**Australian Government**  
**National Capital Authority**

# **Report on Consultation Development Control Plan**

*Manuka Circle Precinct, Canberra Avenue*

*November 2017*

Figure 1 – Area covered by the Manuka Circle Precinct DCP, previously approved DCPs and sites that were not previously subject to a DCP

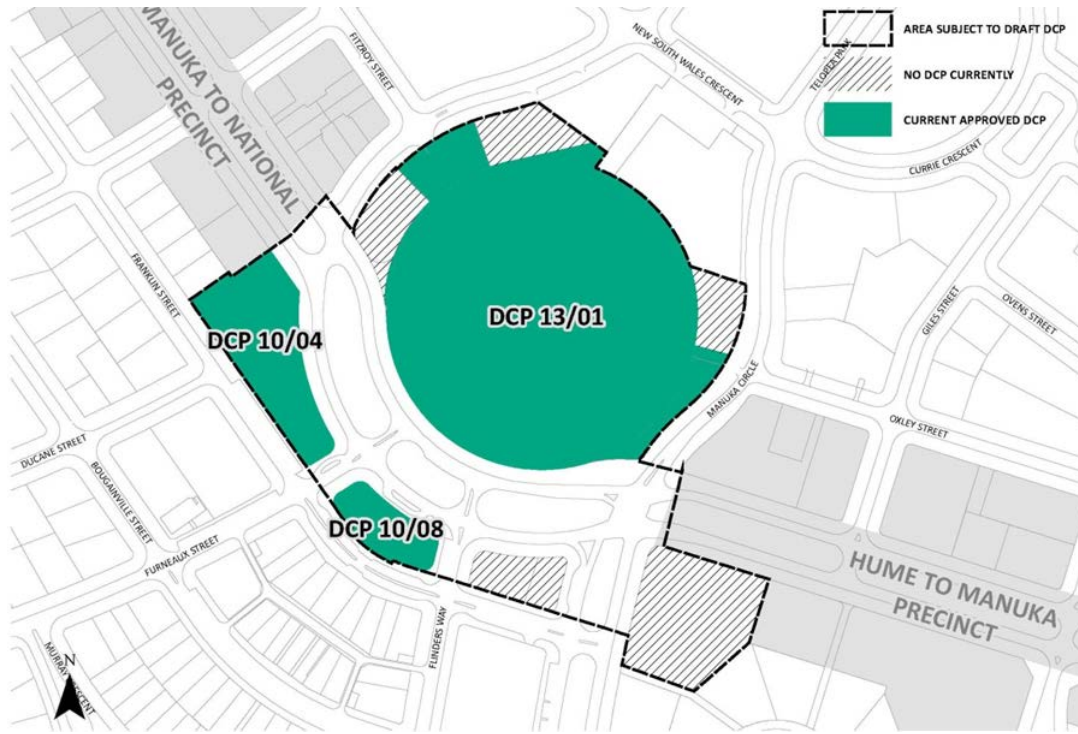
<p><b>EXTENDING THE DCP AREA</b></p> <p>There is strong community support for a planning area that extends beyond Manuka Oval itself. The motions passed by the 28 April 2016 community meeting on the Manuka Oval unsolicited development proposal by GWS and Grocon called for a broader planning area to be considered than just the Manuka Oval precinct.</p> <p>I realise that the NCA may not be in a position to extend the proposed DCP area significantly. Nevertheless the proposed DCP area should be extended so it includes the remainder of Manuka Circle (Manuka Pool and the Manuka Arts Centre) and neighbouring places that commercially relate to the Manuka Centre.</p> <p>It is not clear why the Manuka Pool and the Manuka Arts Centre have been left out when they are in Manuka Circle. It seems logical that all places within Manuka Circle should be included in a DCP for the Manuka Circle precinct. Another reason to include these places is that they are an integral part of the heritage landscape setting that is so valued for the whole of Manuka Circle.</p>	<p>See key issue <a href="#">‘Area Subject to DCP’</a>.</p>

<p><b>4. Objection to the draft DCP</b></p> <p>Because the only area impacted by the draft DCP is ‘Area A, Manuka Oval’, the subject of the draft DCP being described as being concerned with Canberra Avenue as a Main Avenue as defined in the National Capital Plan, is at best misleading.</p> <p>The draft DCP extends well beyond the Canberra Avenue to Manuka Oval areas remote from Canberra Avenue.</p> <p>The Draft DCP makes very significant changes to the existing DCP, as notes in 3 above, without any supporting reasons.</p> <p>I propose that the Draft DCP be rejected.</p> <p>If the NCA considers it appropriate, the existing DCP noted at 2 above should be amended incorporating desired changes and submitted to public consultation.</p>	<p>The draft DCP applies to a number of areas fronting Canberra Avenue including Manuka Oval which is considered to be an important element adjacent to the Main Avenue. See key issue <a href="#">‘Area subject to DCP’</a>.</p>

The NCA notes the preference for including sites adjacent to Manuka Oval (Manuka Arts Centre and Manuka Pool) however, the NCA has made an interpretation of the requirements of the National Capital Plan when defining the area subject to this DCP based on the relationship or the area to Canberra Avenue.

No changes to the DCP are proposed in response to this issue.
